MEMORANDUM

Date: January 17, 2014
To: Water Right File 63-31630
From: shemenway
Re: 63-31630 Field Report Narrative and Licensing Review

For: Licensing Review for the City of Meridian - Municipal Well Sites 63-31630 and 63-31318

Hachmen, I D.P. Tag 7, - LCC50885 CITY OF MERIDIAN #25 SUPPLY WELL PROPOSED WELL CONSTRUCTION

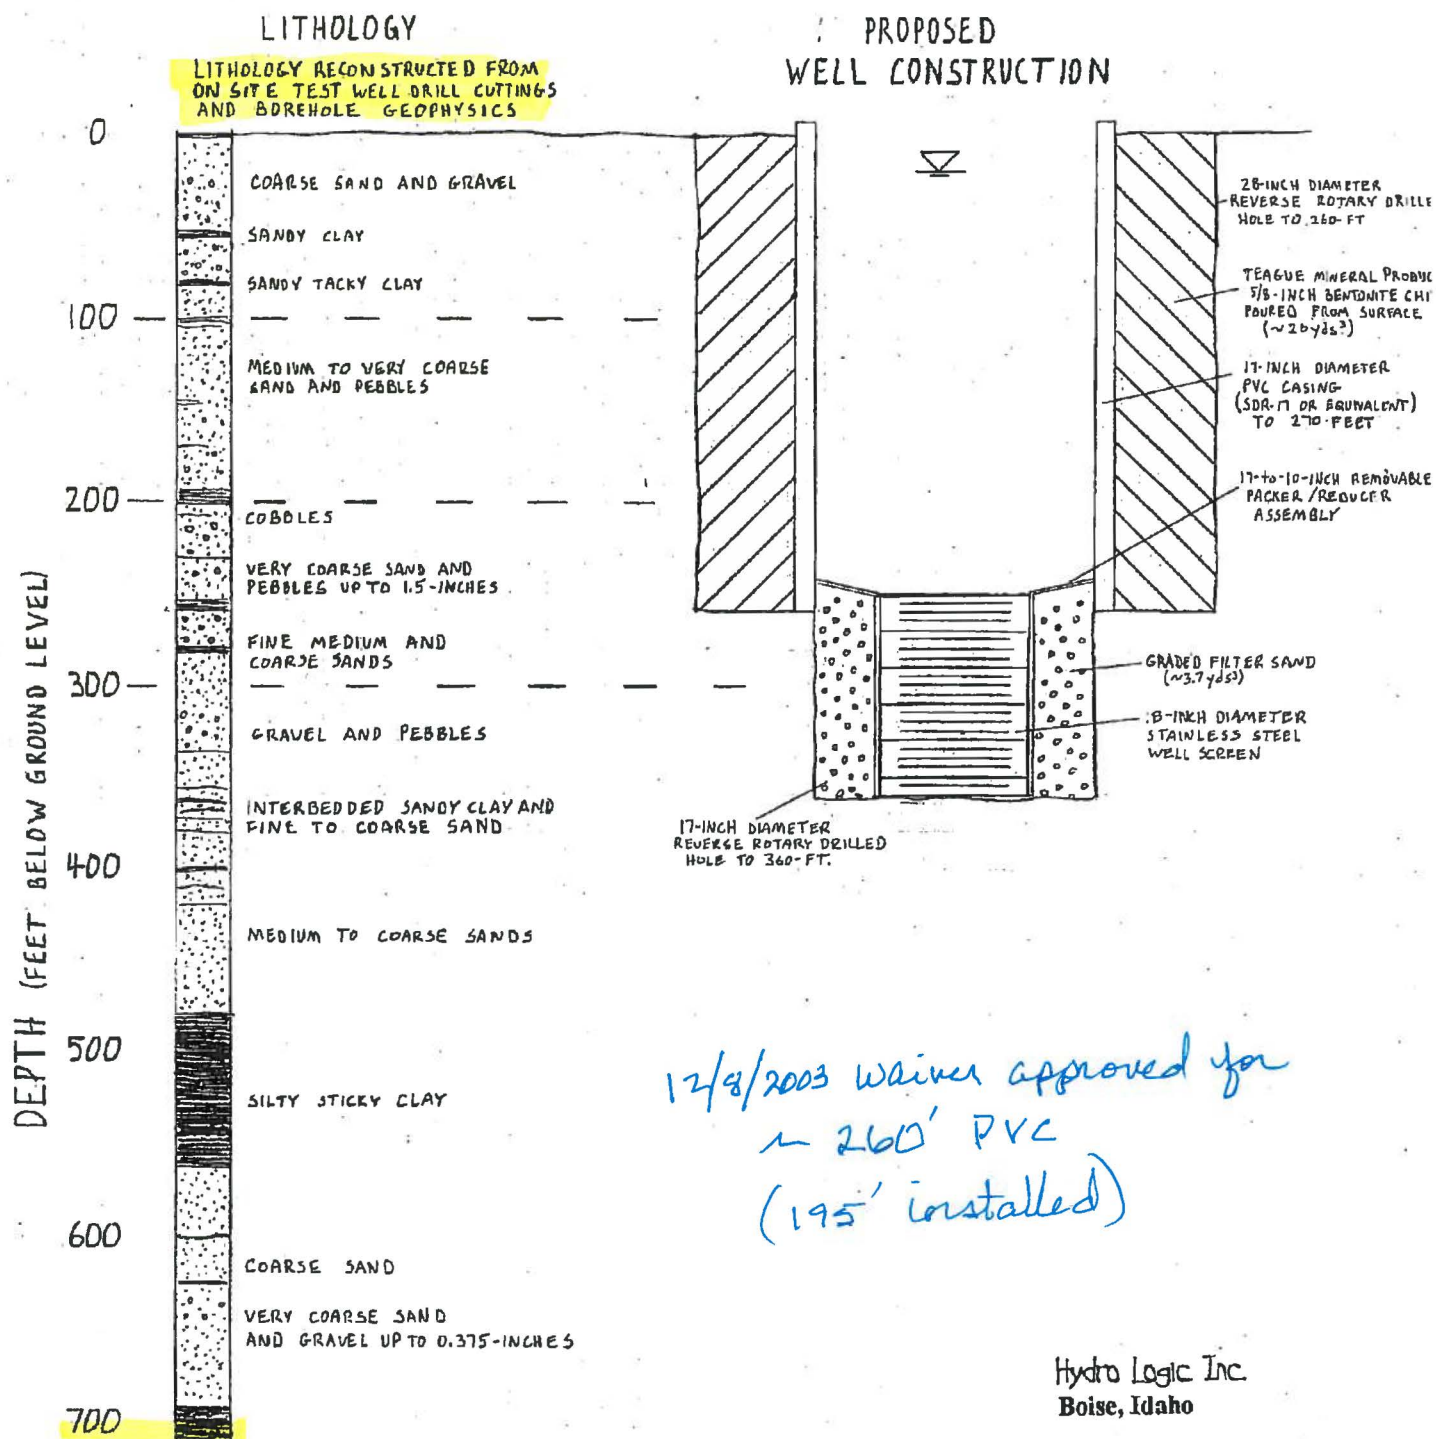
- The final construction of the well violates the affidavit for publication that stated the water bearing zone to be appropriated is 300 to 900 feet.
- Although the well was constructed with the screened interval as shallow as 183 feet below land surface, the diagram included in the water right file indicates that the well was drilled to over 700', with adequate producing water bearing zones below 500 feet, that if completed within this zone, would have satisfied the agreement with BOR and the conditions included on the permit. It does not appear that the shallow completion selected for the final construction of the well was the only option available, based on the well schematic included in water right file.

- The final construction of the well violates the affidavit for publication that stated the water bearing zone to be appropriated is 300 to 900 feet.
- Although the well was constructed with the screened interval as shallow as 183 feet below land surface, the diagram included in the water right file indicates that the well was drilled to over 700', with adequate producing water bearing zones below 500 feet, that if completed within this zone, would have satisfied the agreement with BOR and the conditions included on the permit. It does not appear that the shallow completion selected for the final construction of the well was the only option available, based on the well schematic included in water right file.
